TITLE: AXIALL - CONTACTOR CHANGE FROM US BREAKER TO WEG OVERFLOW PROTECTION TERMINATION POINTS

CONTACTOR REPLACEMENT

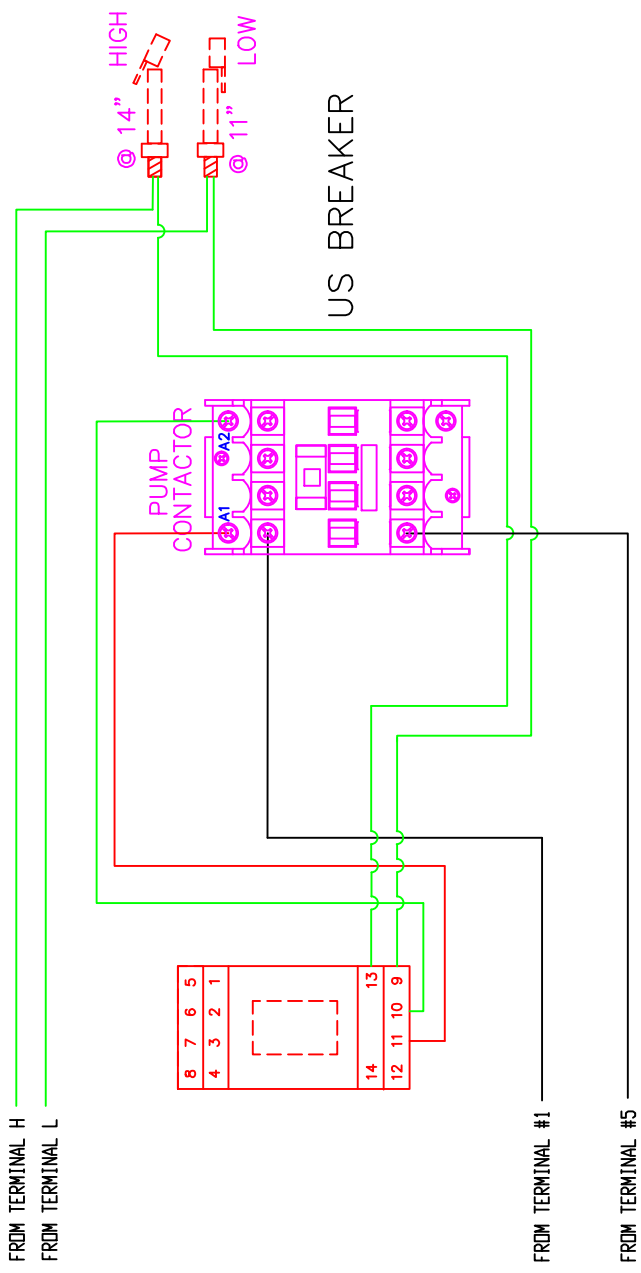
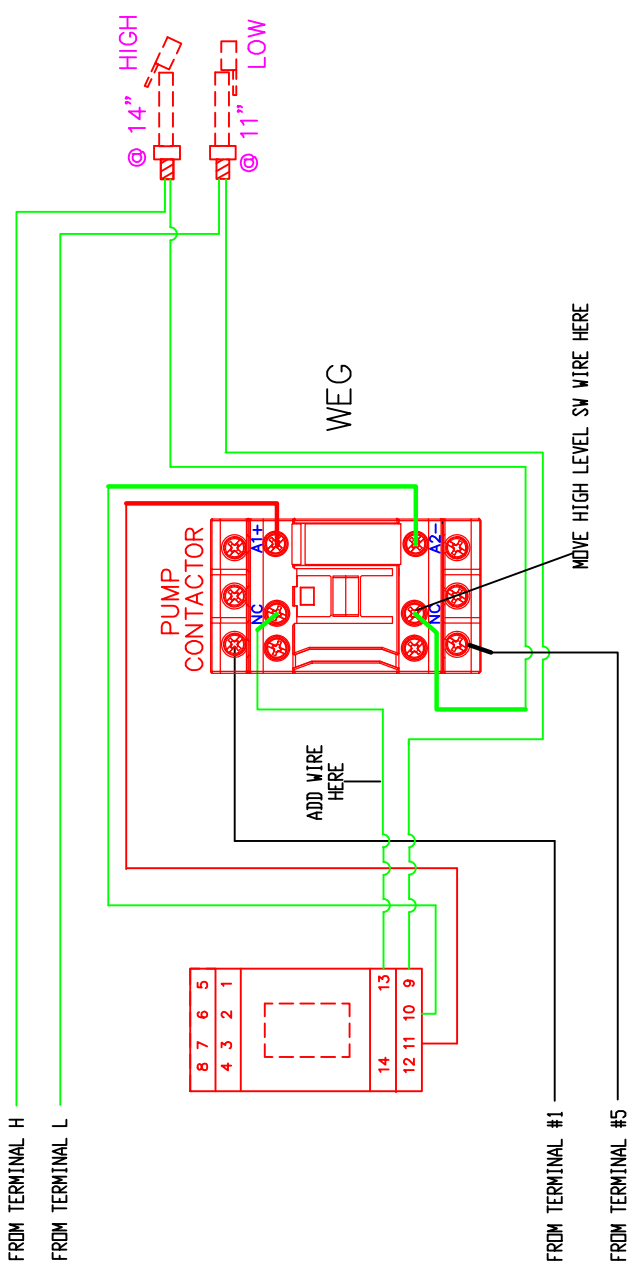
1. ADD A WIRE FROM TERMINAL #13 OF LATCHING RELAY TO THE TOP NC ON THE NEW CONTACTOR
2. WIRE FROM HIGH LEVEL SWITCH WILL MOVE TO BOTTOM NC ON THE NEW CONTACTOR
